SERVICE BULLETIN

FUJI HEAVY INDUSTRIES LTD.

NO. 200-009

1. SUBJECT : Inspection and Repair of Elevator Torque Tube

FIGURE 1

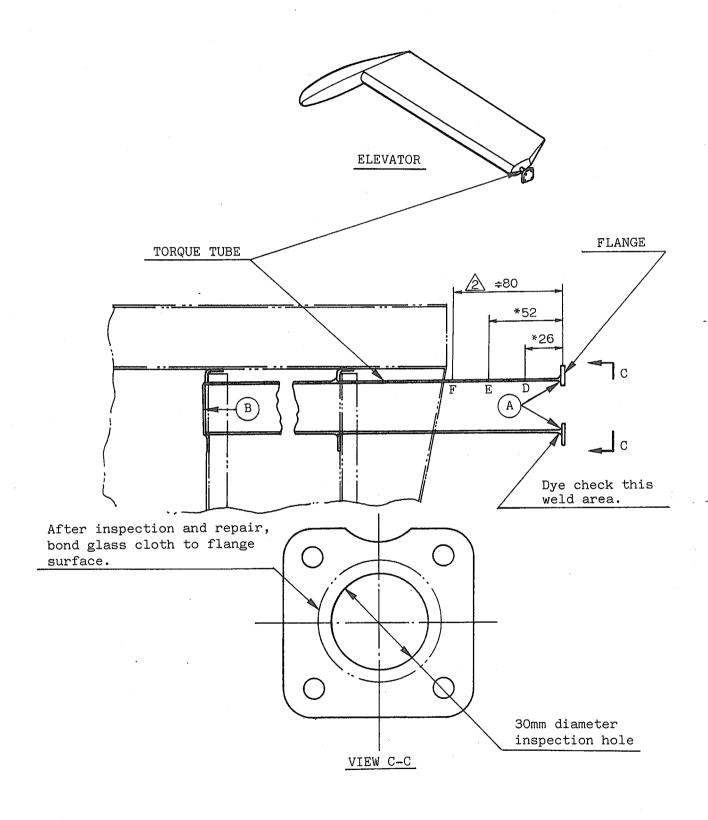
- 12. DETAILED INSTRUCTIONS:
 - (1) Remove elevator in accordance with Service Manual, Paragraph 8-5-1.
 - (2) Drill 30mm diameter hole in flange at the inboard end of elevator torque tube. (See figure 1, view C-C.)
 - (3) Using a bore scope or mirror, inspect the internal surfaces of elevator torque tube for evidence of corrosion or unusual condition.
 - (4) If no corrosion is found on the internal surfances, proceed with step (10).
 - (5) If corrosion is found, remove corrosion using wire brush or rotary brush.

Thoroughly remove corrosion, particularly corrosion at the internal corner of flange. (See figure 1, area (A).)

Measure wall thickness in area of figure 1. Measurements should be taken at diameters D, E, and F with at least four (4) circumferential points equally apart.
- (8) Dye check the weld area, at the inboard end of tube, for crack.
- (9) If any measurement per above step (7) is 0.5mm or less, replace elevator torque tube with like item. If any measurement is more than 0.5mm and inspection per above step (7) reveals no cracks, proceed with the following steps:

- (10) A small hole is existing in the plate at the outboard end of elevator torque tube. (See figure 1, area (B).) Plug this hole with ProSeal 890 B-2 or equivalent. (Apply sealant to the tip of a long rod, and plug the hole.)
- (11) Apply zinc chromate primer or equivalent to the internal surface of tube.
- (12) Cover 30 mm diameter hole, drilled per above step (2), with glass cloth impregnated with EPON 828 or equivalent adhesive.
- (13) Install elevator in accordance with Service Manual, Paragraph 8-5-2. At installation of elevator, apply PreSeal 890 B-2 or equivalent to the exterior surface of flange, and then attach to the mating arm assembly.
- (14) The inspection imposed by this bulletin is repetitive and shall be accomplished each 1000 hours or each five (5) years, whichever occurs first.
